- **Planning Inspectorate Reference:** APP/Z3825/W/25/3362988
- **Horsham District Council Reference:** DC/24/0941
- **Name of Appellant(s):** Mr & Mrs Brent Dowson
- **Description of Application:** Demolition of Waterside House and rear barn. Erection of replacement building to provide 10 no residential apartments

Site at: Waterside House, 17 Lower Street, Pulborough, West Sussex, RH20 2BH

Objection to Planning Application Ref: DC/24/0941

Figure 4: Proposed new building footprint vs existing building footprint (dotted line)

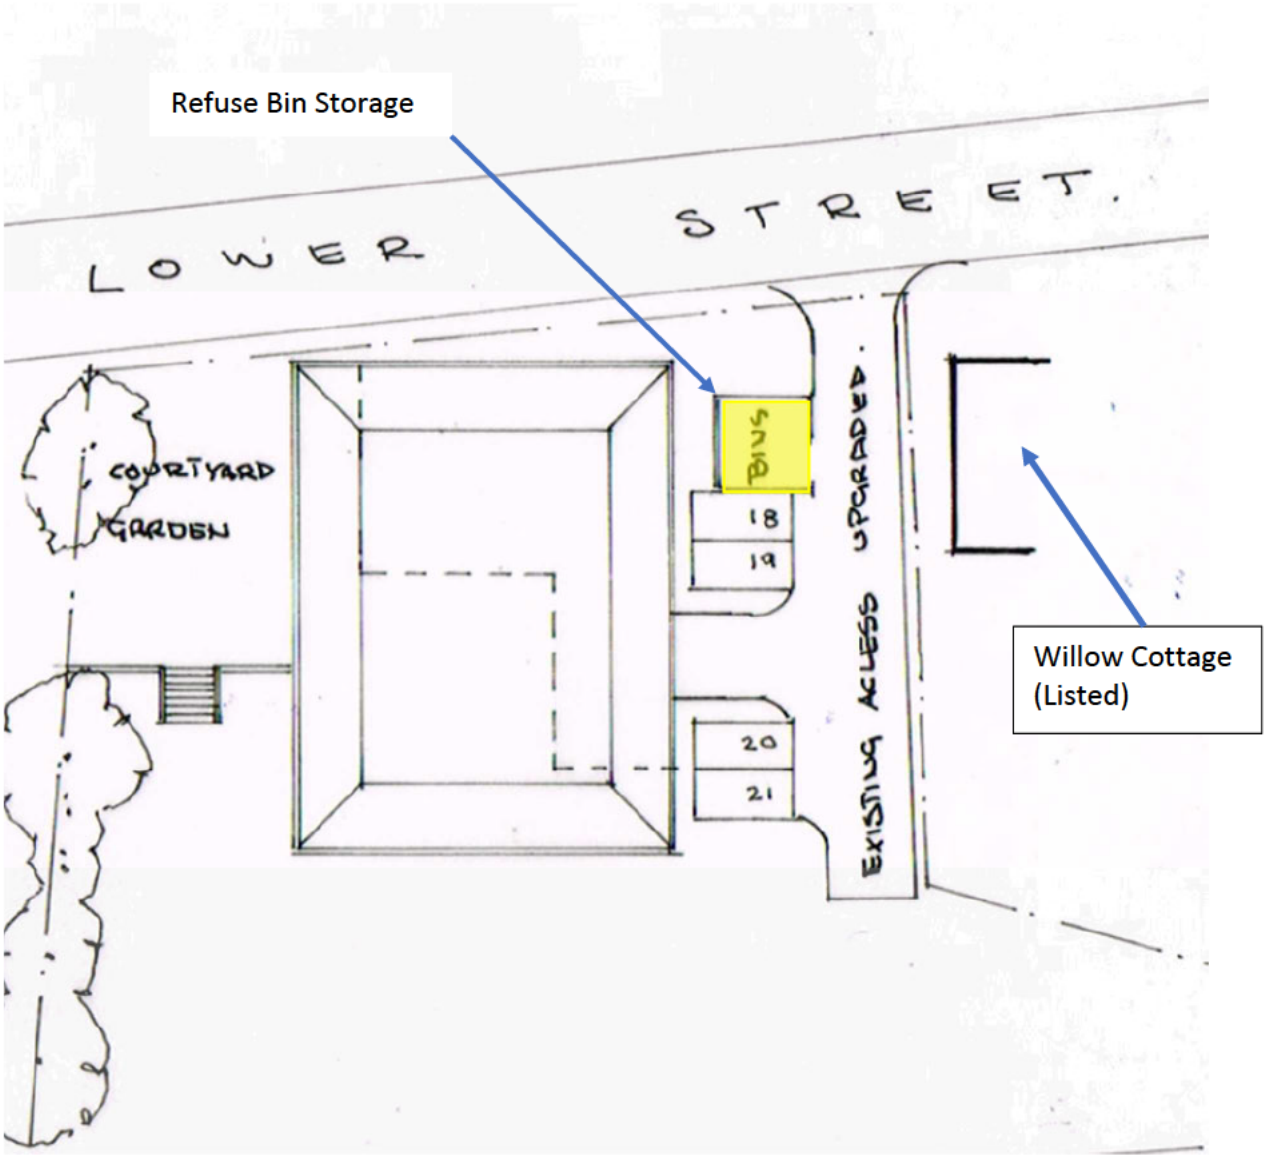
The significant increase in the size and massing of the proposed 10 apartment building does not meet the requirements of the Pulborough Conservation area. It appears the size (floorplan square footage) for the proposed development would increase by at least 300% Specifically:

- The southerly extension at three stories materially reduces views through the site and onto the South Downs National Park AONB
- The southerly extension at three stories negatively impacts views into the Pulborough Conservation area from the South Downs National Park AONB (views into the Conservation area are a stated consideration for the area)

- The amenity of listed Willow cottage will be significantly impacted due to the extended height and length of the proposed building. It will dominate the view, in direct conflict with the Conservation Area requirements.

- The addition four carparks (numbered 18-21 in Figure 4) and din store detract from the amenity of listed Willow Cottage
- Refuse Bins:
    - The application proposes a location for bins next to the external car parks, opposite to and in direct line of site of the listed Willow Cottage.

- If individual bins are used:
        - 30 bins (3 bins per household (1x waste, 1x recycling, 1x green/garden waste) x 10 houses) would need to located in the marked area on Figure 4. The size of the bin area does not appear to support this many bins. This would be significant visual detraction and impact to views of and through the site

Image 9 – Fluvial flood levels – Appendix C, Nijhuis Industries Report

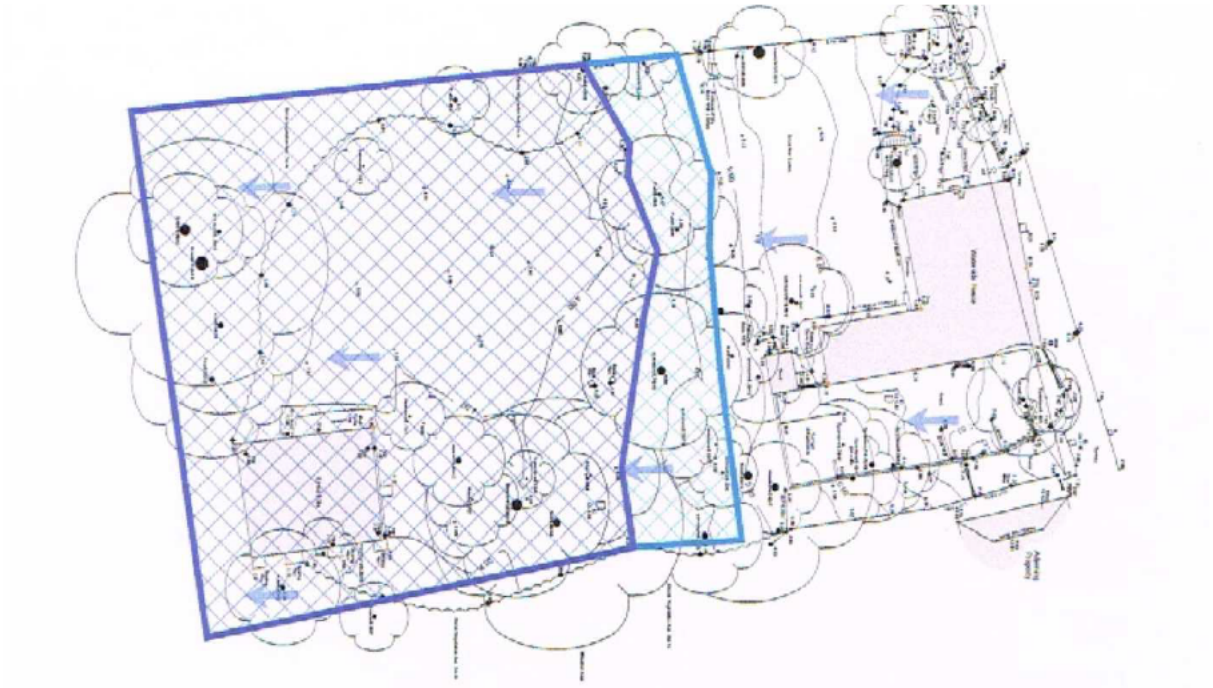
The views of and through the Conservation Area, including to & from the South Downs National Park AONB will be materially worsened when looking upon flooded dwellings, flood isolated buildings and access structures. The southerly extension of the proposed 10 apartment building will bring it very close to fluvial flood levels (*per Image 9)*.

- Presumably the system would be located on the lower part of the property, which is exposed to flooding per Images 7, 8 & 9. How would this system be protected from flood waters?
- How would the system be sized to manage the flood water shown in Images 7, 8 & 9?

Image 10 – Section 3.5 from Nijhuis report

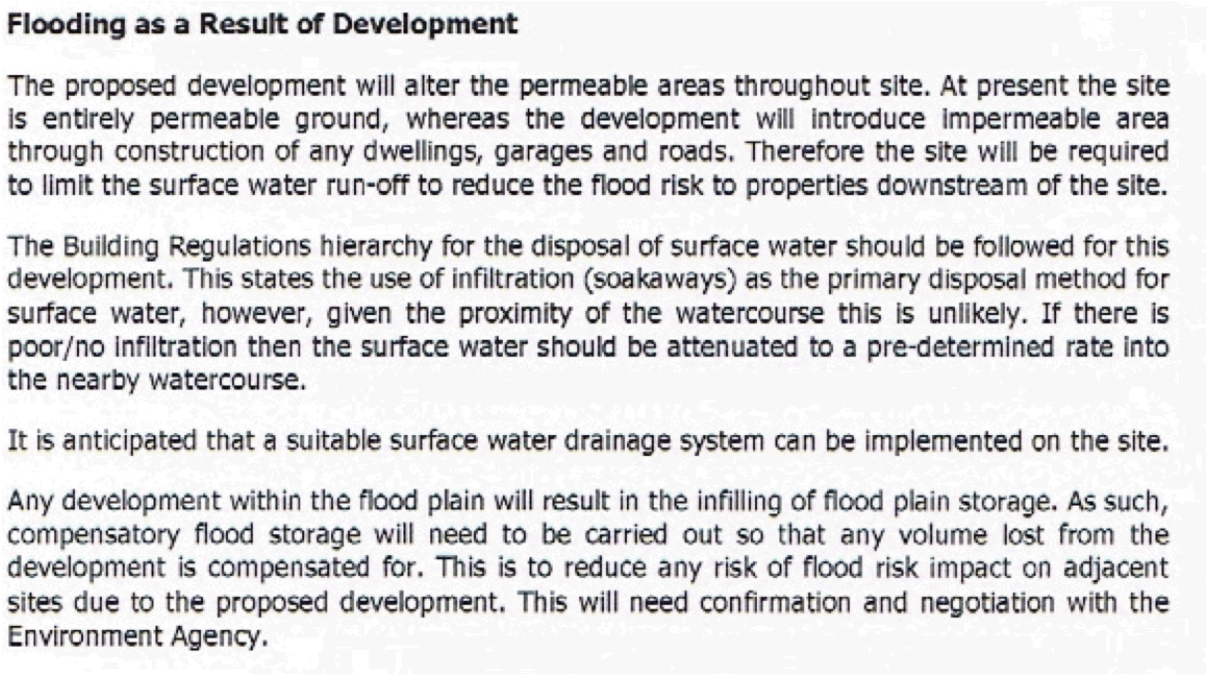
The application makes no provision for:

- surface water arising from the development
- provide any details of a suitable water drainage system
- provide any details for compensatory flood water storage

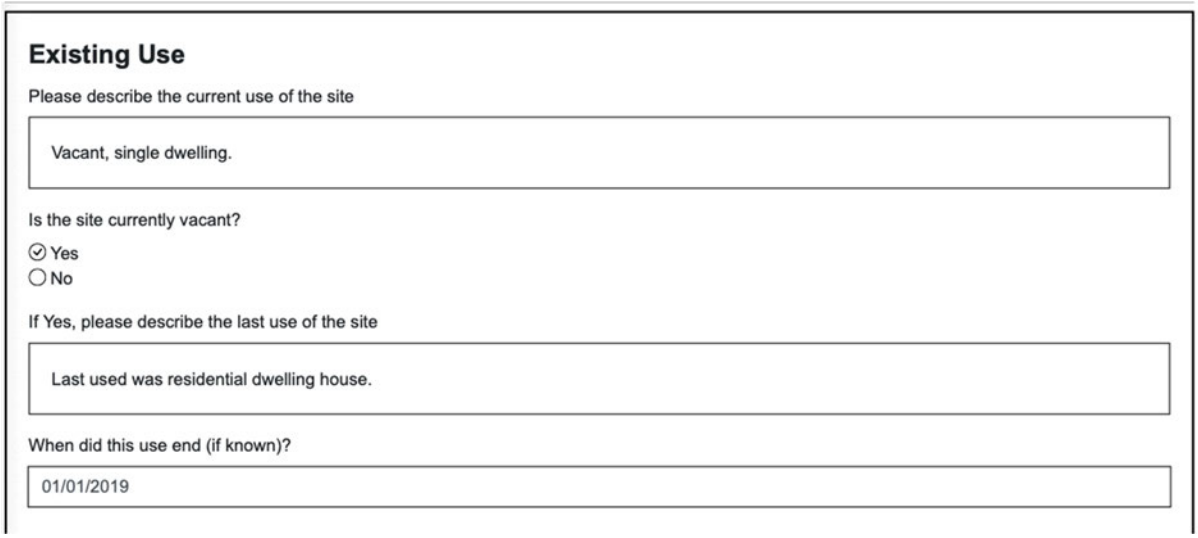
Refusal of a previous Planning Application DC/11/0805 (erection of 1x 4 bedroom dwelling) at Waterside House included a specific objection from WSCC and PPC due to risks associated with access and egress from the site and it's proximity to a bend.

"Reason: The increased use of the existing access to the public highway would add to the hazards of highway users to an unacceptable degree."
